Subject: MHI's Response to US-APWR DCD RAI No. 209-1803

Response to Request for Additional Information No. 209-1803,
Revision 1

US-APWR Design Certification
Mitsubishi Heavy Industries
Docket No. 52-021

RAI NO.: NO. 209-1803 REVISION 1
SRP SECTION: 03.09.03 - ASME Code Class 1, 2, and 3 Components
APPLICATION SECTION: 03.09.03
DATE OF RAI ISSUE: 02/25/09

Figure 1 The schematic diagrams of typical phenomenon of the depressurization wave propagation during LOCA (Reference 1)

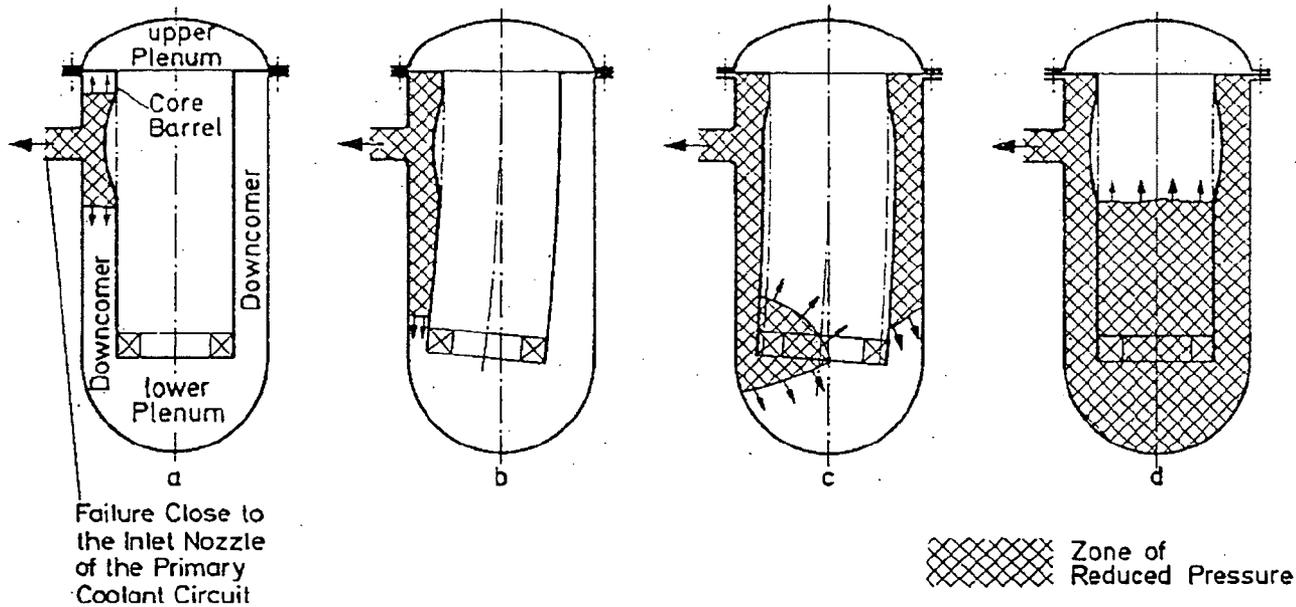
- (c) Also, in DCD Section 3.9.3.1.4 for RCL piping model it is stated that external loads are applied to the RCS piping for connecting piping that does not meet the LBB criteria. Explain what types of pipe break loads are applied to the RCL piping at the branch connections and how these loads are determined. Also, clarify if only the lines satisfying LBB criteria are modeled as part of the RCL piping model, thus excluding all lines that do not satisfy the LBB criteria.

In case of a cold leg break, the depressurization wave generated at the break point propagates through the inlet nozzle of the RV and extends into the annulus (downcomer) between the core barrel and the vessel. In the early phase of LOCA, decompression could take place on the side of the RV annulus nearest to the pipe rupture point before the pressure on the opposite side of RV changes. This instantaneous differential pressure across the core barrel could induce lateral loads both on the core barrel and on the RV, see Figure 1 of Reference 1 below.

The asymmetric blowdown loads due to postulated piping breaks are analyzed by MULTIFLEX computer code, which can provide the load conditions (forcing function which is used as input data for the dynamic system analysis) for components in the primary coolant system, and internals and supports in the RV. The main characteristics of MULTIFLEX are described in Reference 2 below.
